RE: CEP – Cooling Tower Expansion Project

Re: Notice of Intent to Construct – Type 1 Change, ACDP #25-0006-ST-01
Pacific Ethanol Columbia, LLC - Boardman, Oregon

Attachment 1: ODOE's Change Request Evaluation and Determination

Figure 1: Site Layout of Cooling Tower
Pacific Ethanol Columbia, LLC
Type 1 NOIC May 2017

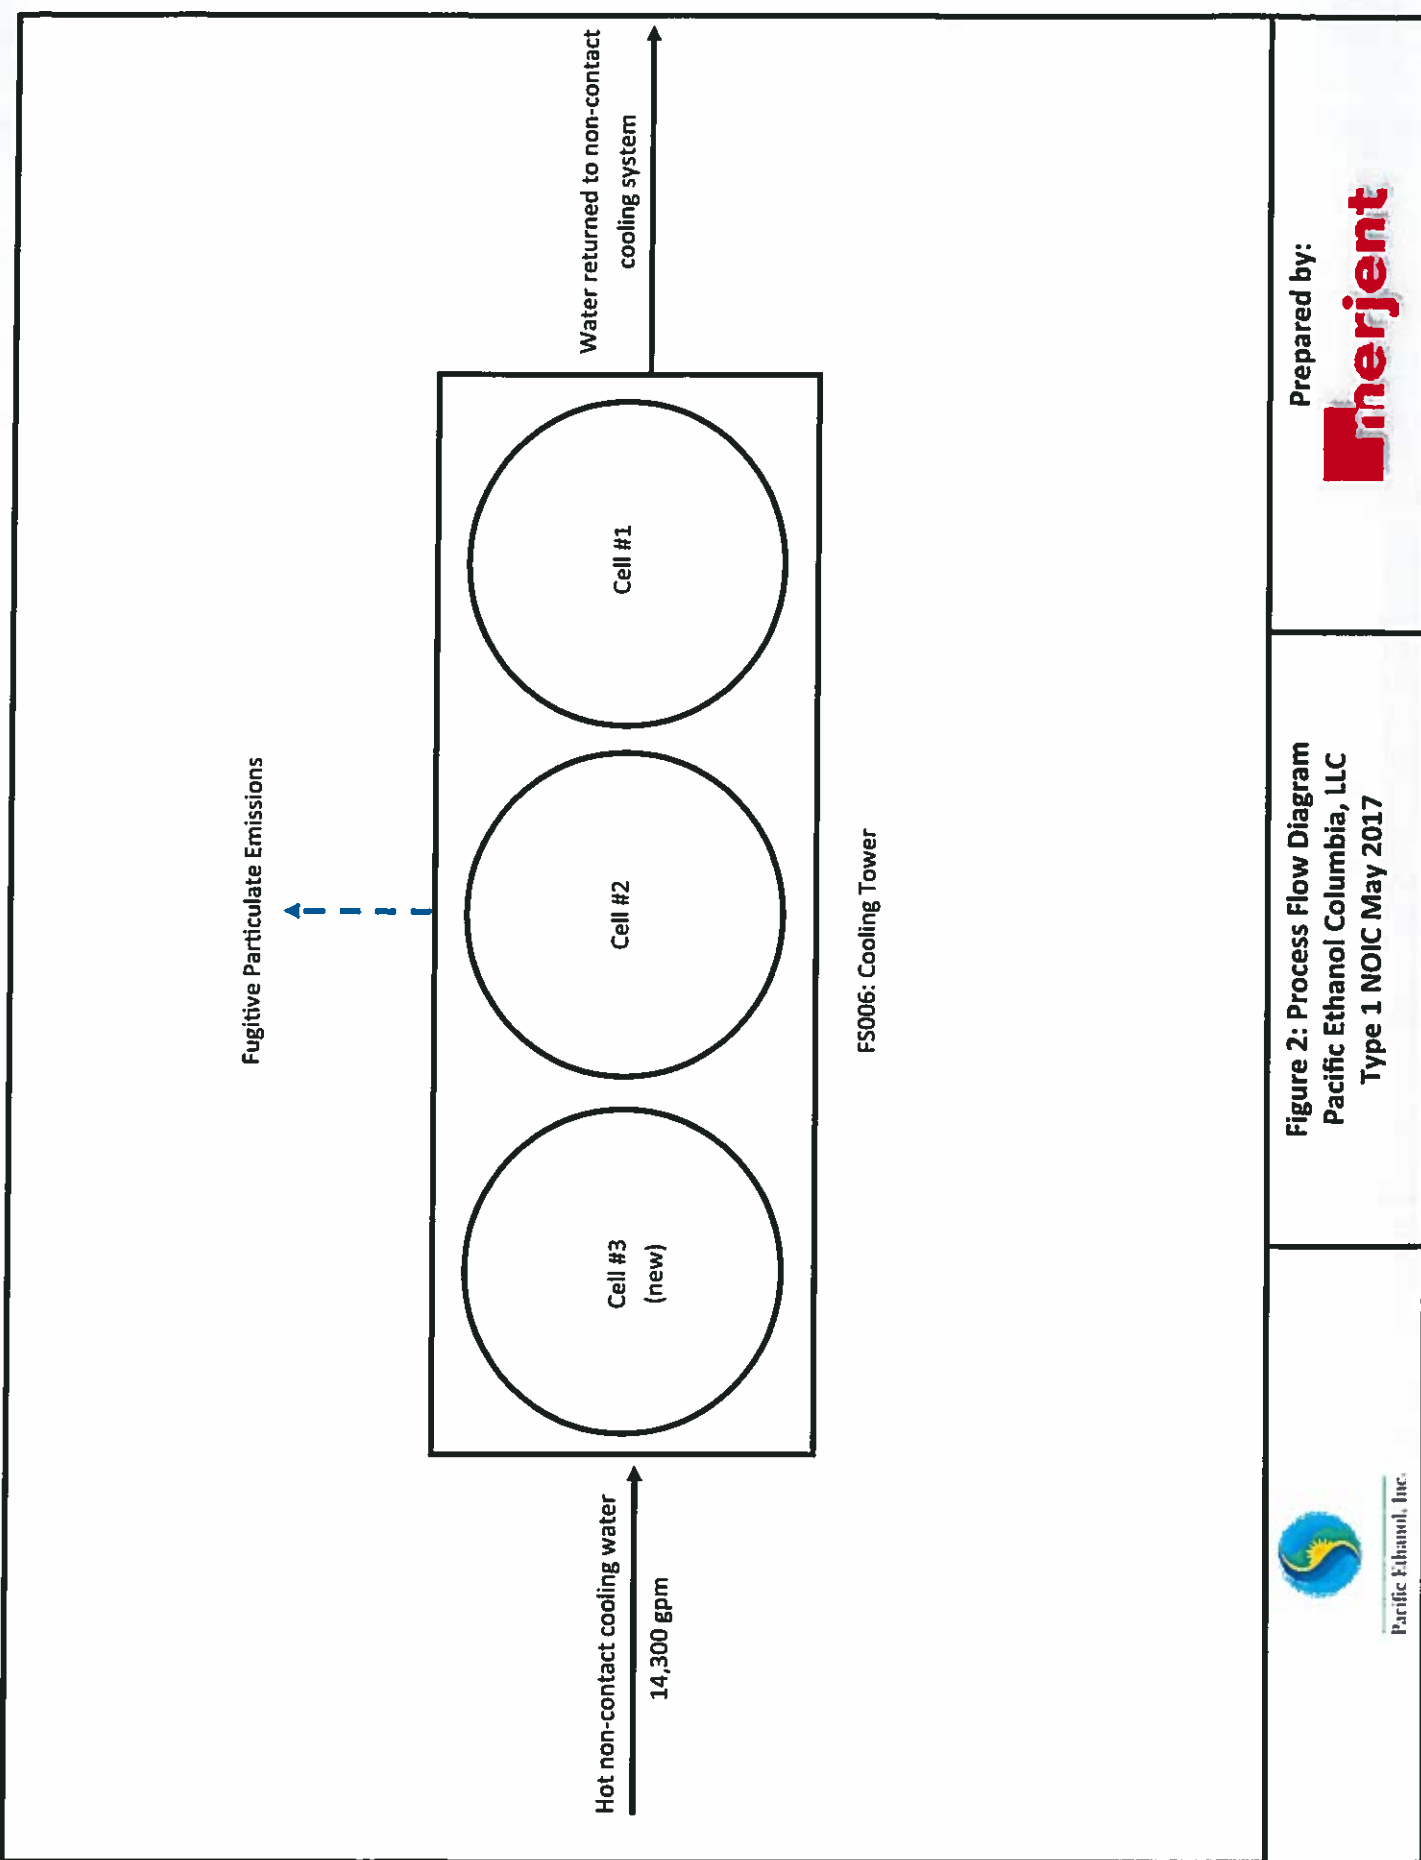
The existing two-cell cooling tower system includes two, 150-foot tall distillation towers located to the north of the main processing building, in between the fermentation tank farm and the ethanol storage tank farm (see attached site plan). The existing cooling tower system receives hot, non-contact cooling water at a rate of 14,300 gallons per minute (7,516.1 million gallons per year) and, through evaporation, releases excess process heat (steam plumes) into the atmosphere. The resulting cooled water is discharged under authorization of existing facility water permits (those permits are administered by DEQ and are outside of the site certificate process). The drift loss rate of the existing cooling tower system is 0.005%; and permitted total dissolved solids concentration is 2,000 parts per million.

The proposed cooling tower expansion project would involve the construction and operation of an additional cooling tower cell, including one new 150-foot tall distillation tower located adjacent to and connected with the existing system. The certificate holder asserts that the system water flow rate, drift loss rate, and total dissolved solid concentration levels would not be impacted, nor change, as a result of the construction and operation of the additional cooling tower cell.

The Department agrees with PEC's evaluation under OAR 345-027-0050 and finds that the proposed cooling tower expansion project would not cause a significant adverse impact to a resource protected by EFSC standards, and does not substantially impair PEC's ability to comply with site certificate conditions. Compliance with applicable EFSC Standards, state and local laws, rules, and ordinances are not expected to be affected by the requested change. In accordance with the requirements of OAR 345-027-0050(4), the certificate holder shall include a description of the modifications and the Department's determination in the next annual report. ODOE will also document the change in an order associated with the next site certificate amendment. Finally, as noted in the cover letter, OAR 345-027-0050(5) allows that at the request of an Energy Facility Siting Council (EFSC or Council) member, the Department's determination must be referred to the Council for concurrence, modification, or rejection. The Department will provide its determination to EFSC, informing Council of their rights under the rule. Should a Council member request to review the determination, the determination would go before EFSC at an upcoming Council meeting.
